**Central Otago District Council
Otago Regional Council**

Land Use Consent RC200343
Water Permit Application RM20.360.01
Discharge Permit Applications to land, water RM20.360.02
Discharge Permit Application to air RM20.360.03
Land Use Consent for a Bore RM20.360.04

Cromwell Certified Concrete Ltd

Memorandum responding to revisions and comments from the Applicant

Mine Plan (Maps 1 to 4)

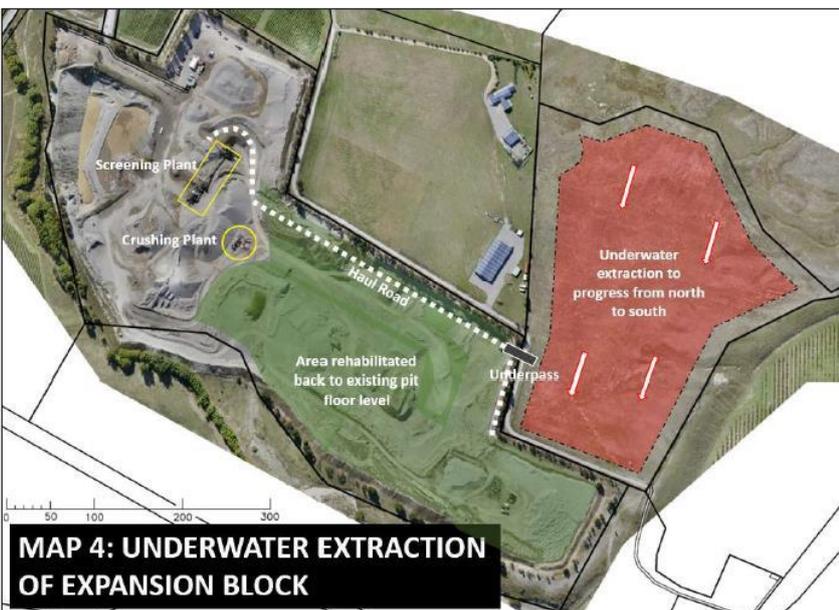
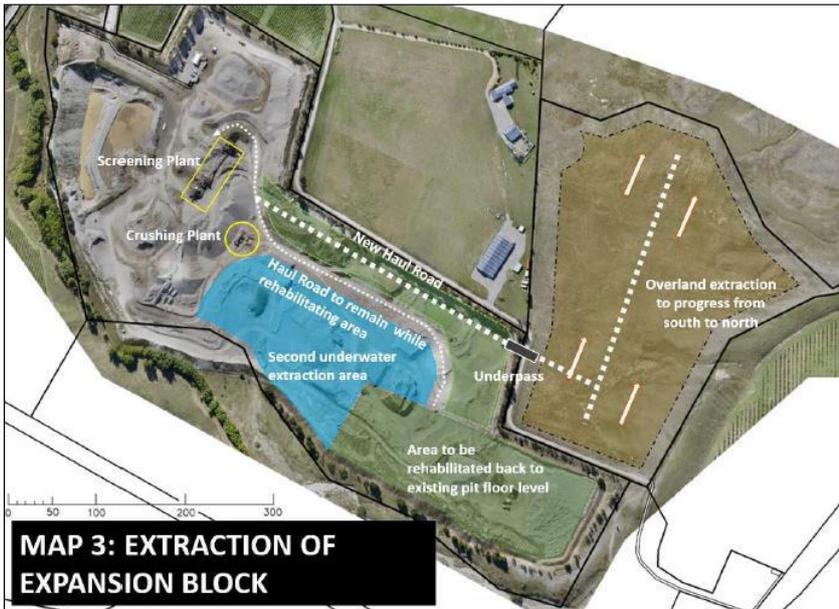
Commented [MC2]: The Site Plan and Mine Plan (Maps 1-4) are the key plans to be referenced.

Commented [MC3]: The 'Temporary Diversion and Bund Extension' and 'Amisfield Quarry Rehabilitation Plan' are now both proposed to be included, noting that the Rehabilitation Plan is in draft form.

In my view, the plan (d) (Temporary Diversion and Bund Extension Plan) should not be referenced in Condition 1 for the reasons set out in my supplementary evidence in reply.
